MODEL
2017MY
Niro (DE HEV)

NUMBER
PS553 (Rev 1, 05/15/2018)

HEV WARNING LIGHT AND DTC P1B25/P1B77

Hi-Voltage Battery Fuse

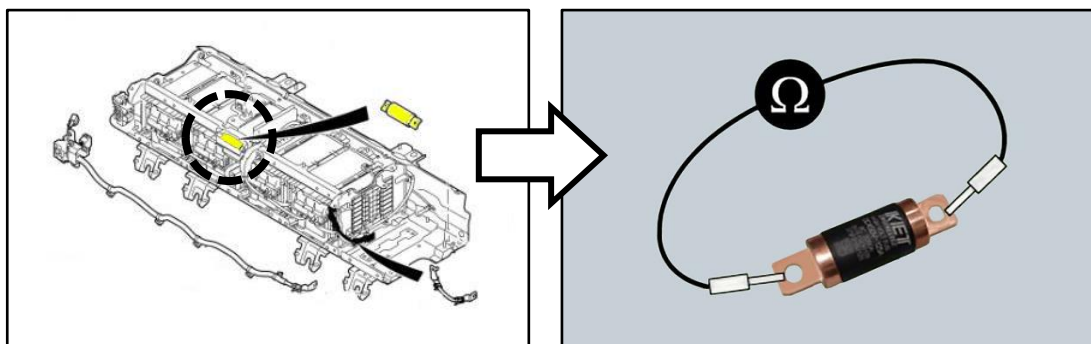
When addressing a concern related to the Niro HV warning light ON, and KDS detects a primary DTC P1B25 (HV Path Fault) and secondary DTC P1B77 (HV Pre-Charge Fault), then the 125 Amp High Voltage Battery Fuse should be inspected for an intermittent and/or an open condition.

Measure the resistance while tapping on the fuse (less than $<1\Omega$ resistance).

Specification: 1Ω or less (68°F)

If the measured resistance is not within specification, or the P1B25 DTC is intermittent, replace the 125 Amp main HV battery fuse with the newer 175 Amp main HV battery fuse.
(Part # 375F2 A8170)
